| Project                      | <b>IEEE 802.16 Broadband Wireless Access Working Group</b> < <a href="http://ieee802.org/16">http://ieee802.org/16</a> >  |  |
| Title                        | <b>Symmetric UL/DL diversity permutations for OFDMA PHY</b>   |  |
| Re:                          | Call for contributions, IEEE P802.16e/D5 Sponsor Ballot   |  |

Figure 219 – Illustration of OFDMA frame with multiple zones

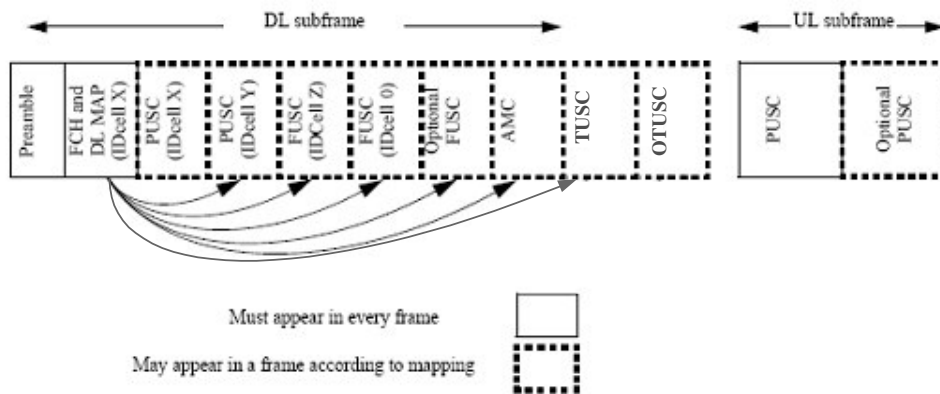
The OFDMA frame may include multiple zones (such as PUSC, FUSC, PUSC with all subchannels, optional FUSC, AMC, ~~and~~ optional FUSC with all subchannels, TUSC, and optional TUSC), the transition between zones is indicated in the DL-Map by the Zone\_switch IE (see 8.4.5.3.4). No DL-MAP or UL-MAP allocations can span over multiple zones. Figure 219 depict OFDMA frame with multiple zones.

### 3. [Replace figure 219 on page 503 with the following figure]

**Figure XXX – Mapping of data subcarriers in STC for TUSC with matrix indicator A.**

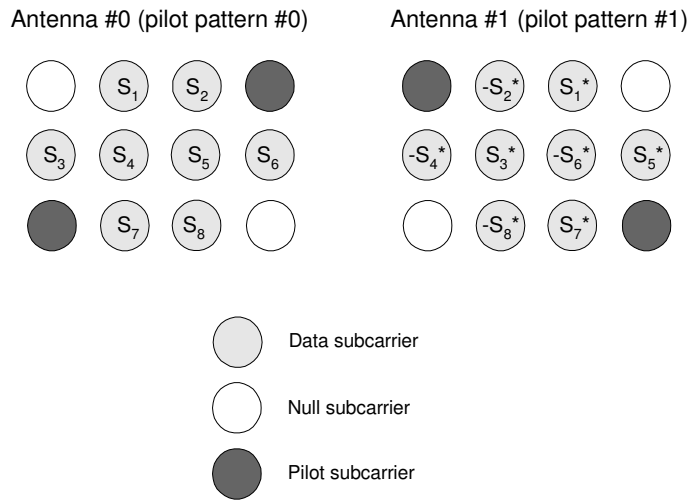
Two STC modes for 2-antenna configuration are defined for the TUSC permutation. In both modes, the pilots in each tile shall be split between the two antennas as depicted in figure XXX. In the first mode, identified by STC matrix indicator ‘A’, data subcarriers are encoded within each tile after constellation mapping. In this mode, the tiles shall be allocated to subchannels and the data subcarriers enumerated as defined in 8.4.6.1.2.4. The data subcarriers transmitted from Antenna #0 follow the original mapping defined in 8.4.6.1.2.4.
